To: T10 Technical Committee  
From: Rob Elliott, HP (elliott@hp.com)  
Date: 6 November 2004  
Subject: 04-370r0 SAS-1.1 Merge IT and IR with XT and XR

**Suggested changes**

**Figure 1 — External cable CT and CR compliance points**

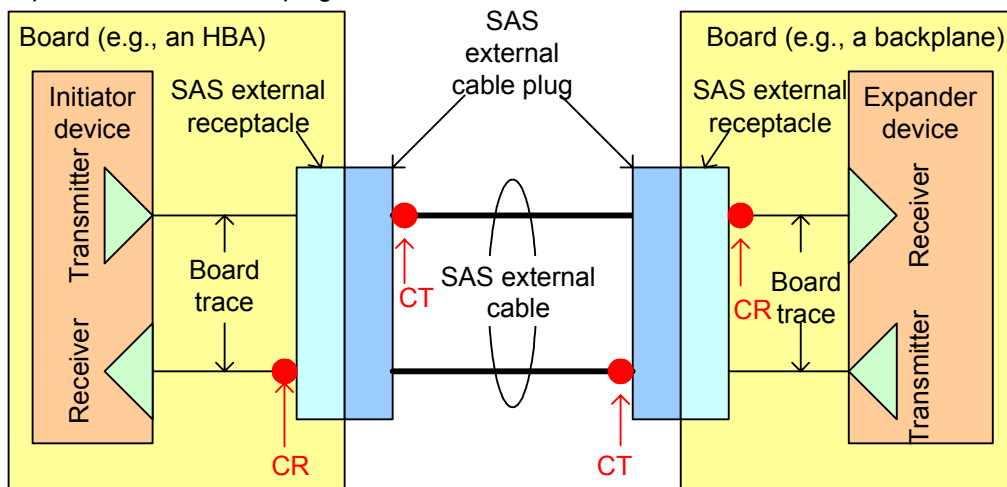
2. There is some confusion over where exactly the compliance points are located. Proposed figures are added showing the location of the compliance points for each type of connector interface.

Figure 1 shows the locations of the CT and CR compliance points using an external cable.

Figure 2 — Backplane IT and IR compliance points

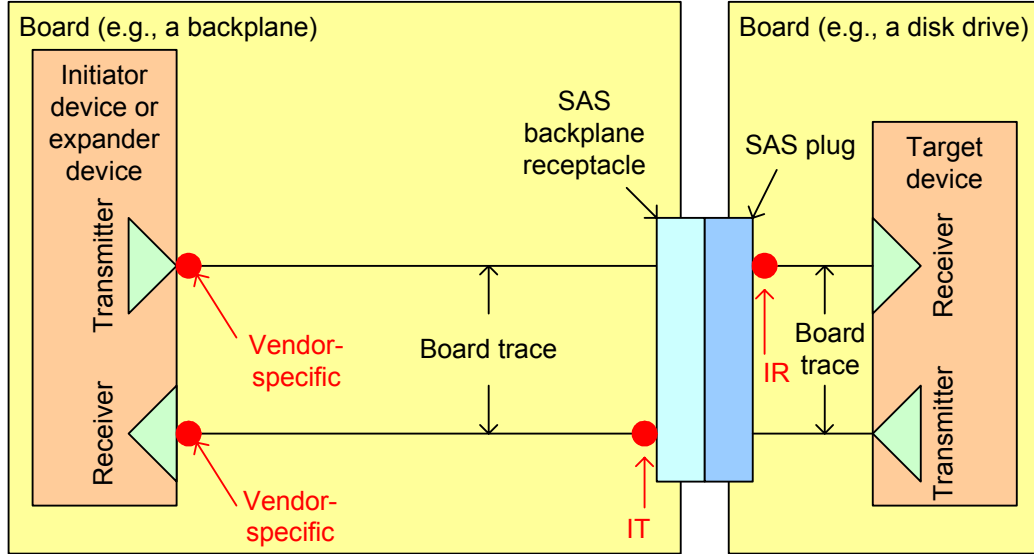
Figure 2 shows the locations of the IT and IR compliance points using a backplane with a SAS backplane receptacle (see 5.2.3.4) that is not attached to a SATA device.

Figure 3 — Backplane compliance points with SATA device attached

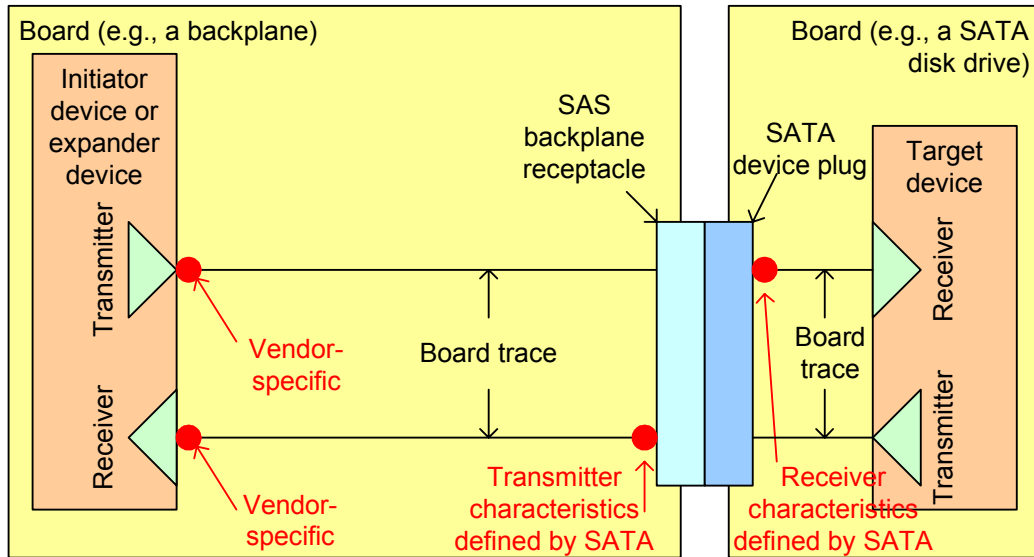
If the backplane supports SATA devices being attached to the SAS backplane receptacle (see 5.2.3.4), there are no IT or IR compliance points. SATA defines the signal characteristics that the SATA device delivers and that the SAS backplane is required to deliver to the SATA device, as shown in figure 3.

Figure 4 — Internal wide cable IT and IR compliance points

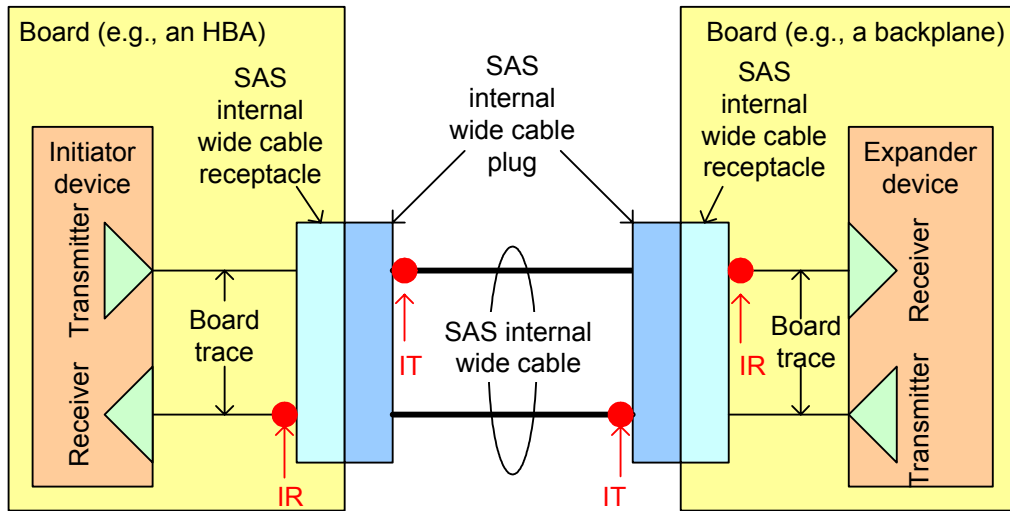
Figure 4 shows the locations of the IT and IR compliance points using an internal wide cable.

Figure 5 — Internal wide cable and backplane IT and IR compliance points

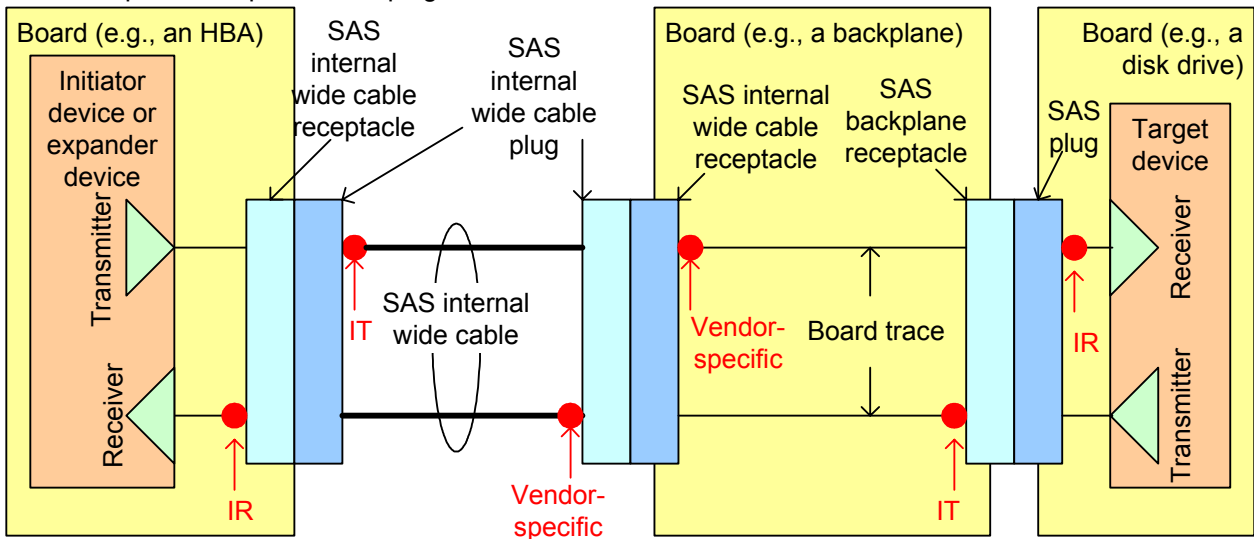
Figure 5 shows the locations of the IT and IR compliance points using an internal wide cable and a backplane, where the backplane is not attached to a SATA device.

**Figure 6 — Internal cable and backplane compliance points with SATA device attached**

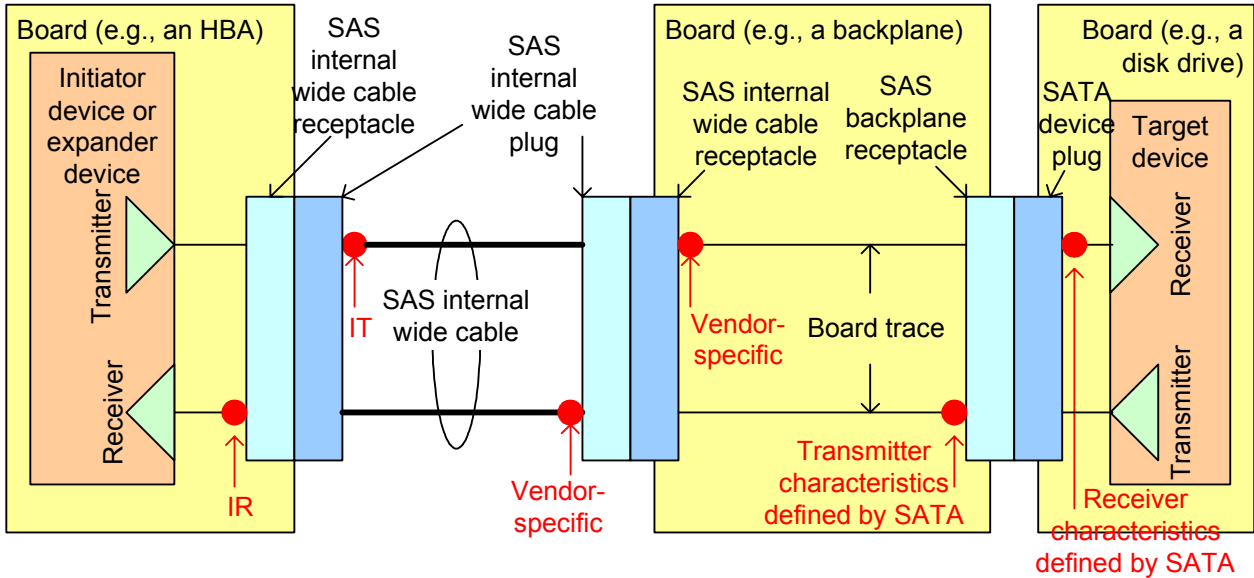
If the backplane supports SATA devices being attached to the SAS backplane receptacle, there are no IT and IR compliance points at that connector. SATA defines the signal characteristics that the SATA device delivers and that the SAS backplane is required to deliver to the SATA device, as shown in figure 6.

**Figure 7 — Internal cable IT and IR compliance points**

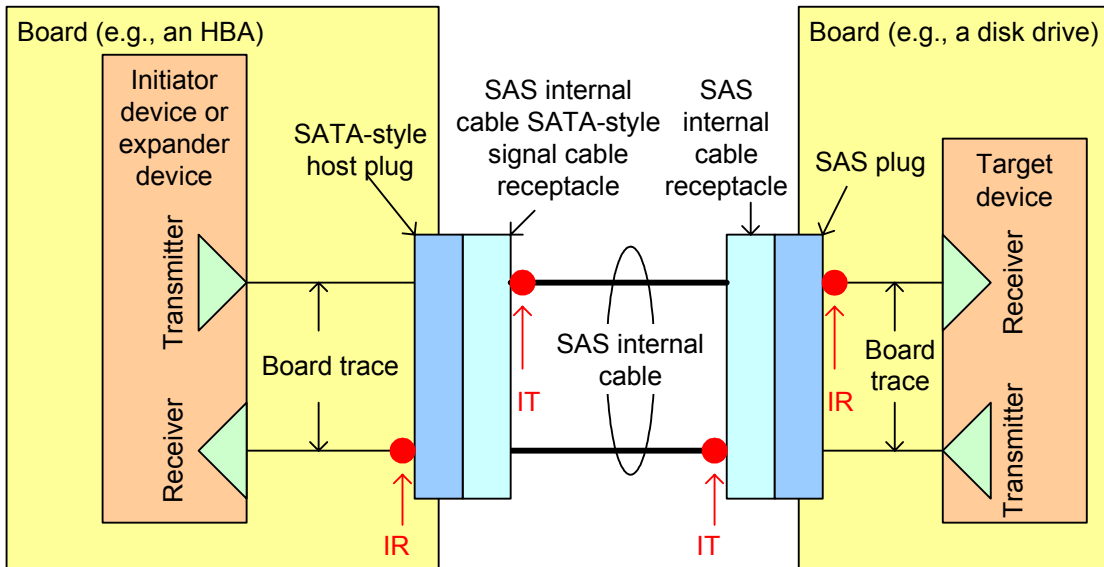
Figure 7 shows the locations of the IT and IR compliance points using an internal cable.

Figure 10 — Eye mask at IR, and CR, and XR

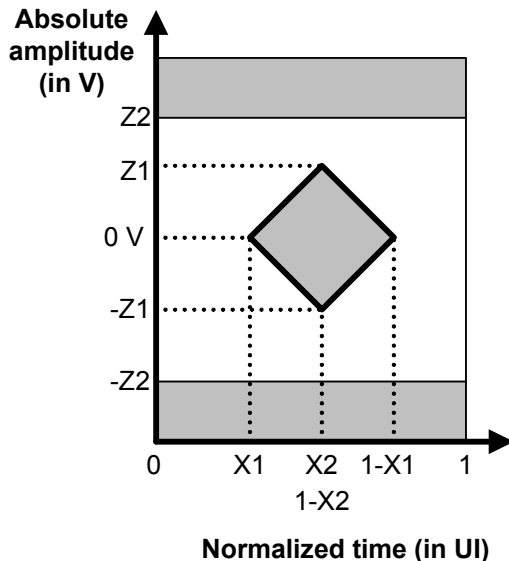
5.3.3.2 Receive eye mask at IR, and CR, and XR

Figure 10 describes the receive eye mask. This eye mask applies to jitter after the application of a single pole high-pass frequency-weighting function that progressively attenuates jitter at 20 dB/decade below a frequency of ((bit rate) / 1 667).

Figure 11 — Deriving a tolerance mask at IR, and CR, or XR

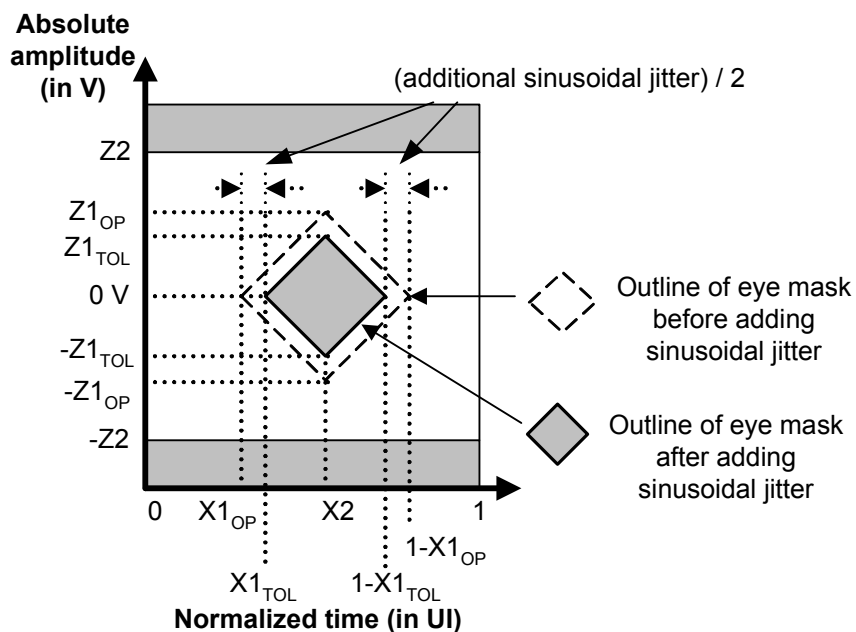
Figure 11 describes the receive tolerance eye masks at IR, and CR, and XR and shall be constructed using the X2 and Z2 values given in table 4. X1<sub>OP</sub> shall be half the value for total jitter in table 5 and X1<sub>TOL</sub> shall be half the value for total jitter in table 6, for jitter frequencies above ((bit rate) / 1 667).
